Supplementary Submission No 114c

INQUIRY INTO CURRENT AND POTENTIAL IMPACTS OF GOLD, SILVER, LEAD AND ZINC MINING ON HUMAN HEALTH, LAND, AIR AND WATER QUALITY IN NEW SOUTH WALES

Bowdens Silver Project - Greenhouse Gas Emissions

Table 4.36 EIS (Source Ramboll (2020) Table 8.1)

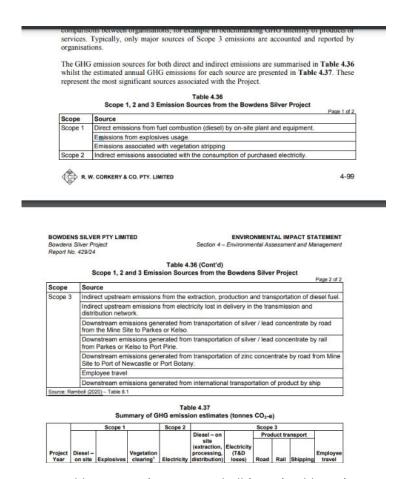
This table is found in the Ramboll Australia Pty Ltd Air Quality Assessment as part of the EIS. It is not the same table (Table 4.36) found on page 4-99 of the EIS. Transport to Kelso has been included in the EIS table without any changes to the emissions calculations in Table 4.37.

RW Corkery and Co have altered tables and other material in their report without explanation. See below Table 4.36 which states Source Ramboll (2020) Table 8.1 which it is not.

There seems to be an error in table 8.1. in the Ramboll Australia Pty Ltd report and also in Table 4.36 in the EIS.

The Scope 3 Emission Sources that are of great concern. The downstream emissions note that 4 downstream emissions are generated from silver / lead concentrate, it is unclear whether employee travel relates to silver / lead concentrate but it may so it will be included

Ramboll Australia Pty Ltd have neglected to include the activity that occurs at Port Pirie, the destination of the silver / lead concentrate. The EIS states that only major sources of Scope 3 emissions are accounted and reported by organisations.

Why is a major downstream activity like the extraction of silver and lead from the silver / lead concentrate excluded from the Emission Sources.
